CERTIFICATE OF APPROPRIATENESS PLACARD

103 N EAST STREET

170-14-MW

Raleigh Historic Development Commission – Certificate of Appropriateness (COA) Application

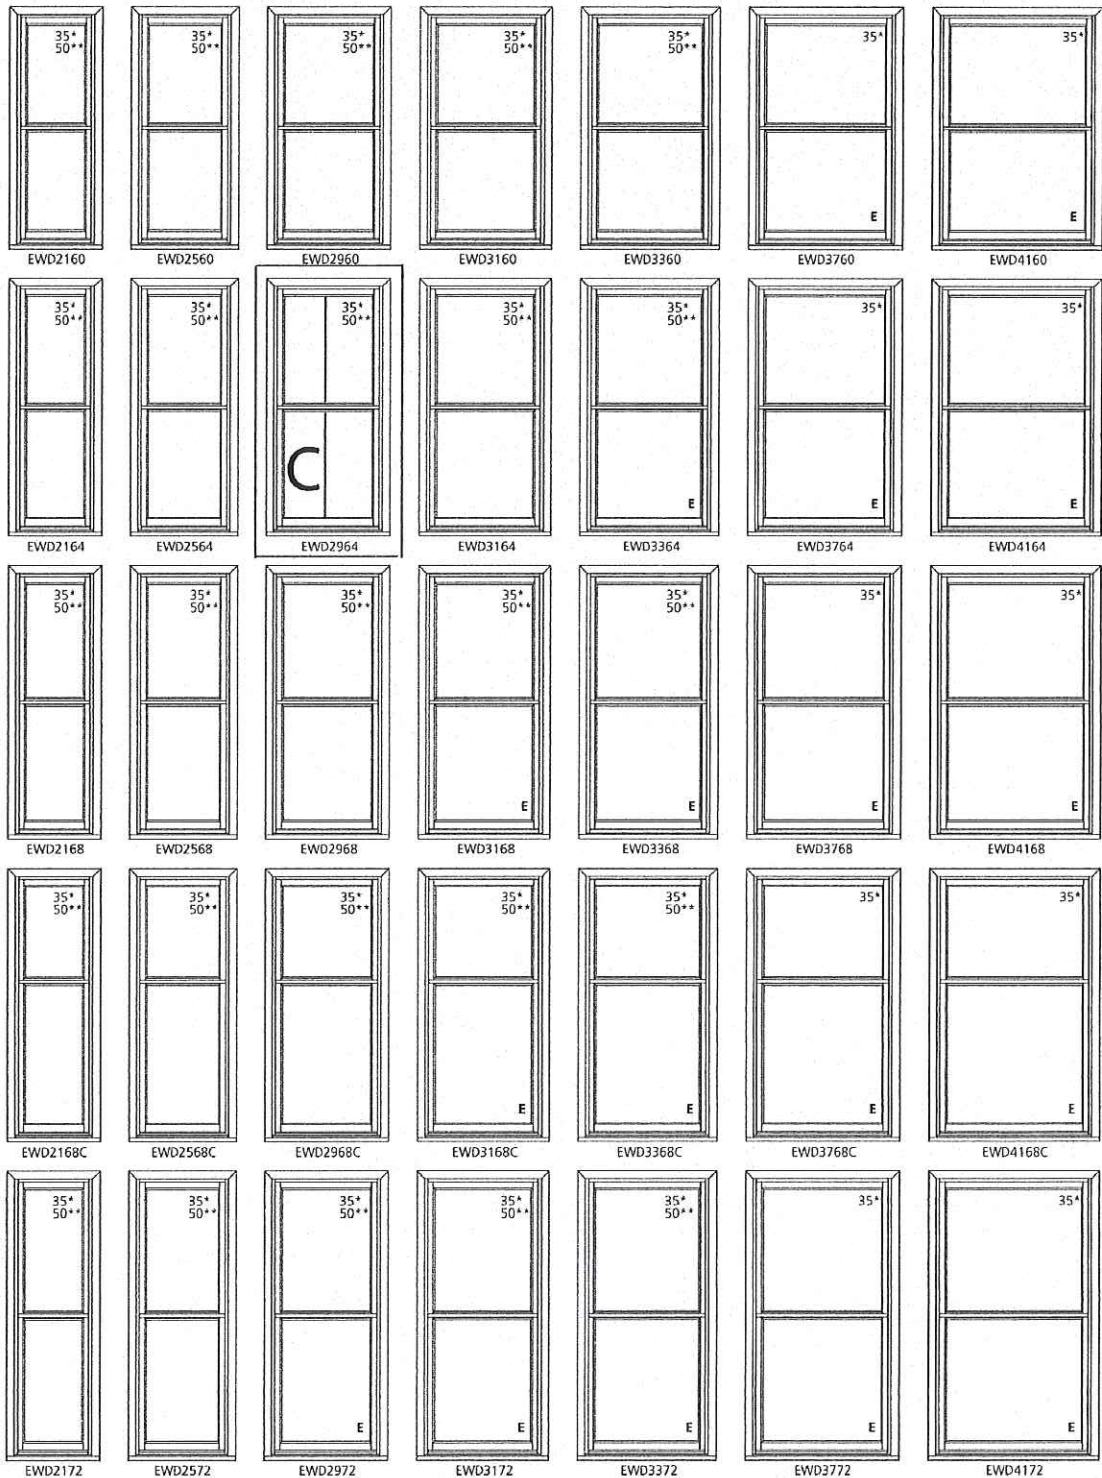
- Muntin detail for the new window on the 2nd level;
- Specifications/section drawings for patio doors;
- Photograph(s) of the yard showing where the shed will be placed.

Here is the mutin-profile (7/8" putty), that window will be a one over one to match the original upstairs windows. The patio door info is attached. They are going to go with an in-swing door instead of the french doors so that size chart is included as well (5068). Horizontal and vertical sections are included as well as the glazing options. The 7/8" SDL shadow bar is the one we are thinking. I will send photos tomorrow.
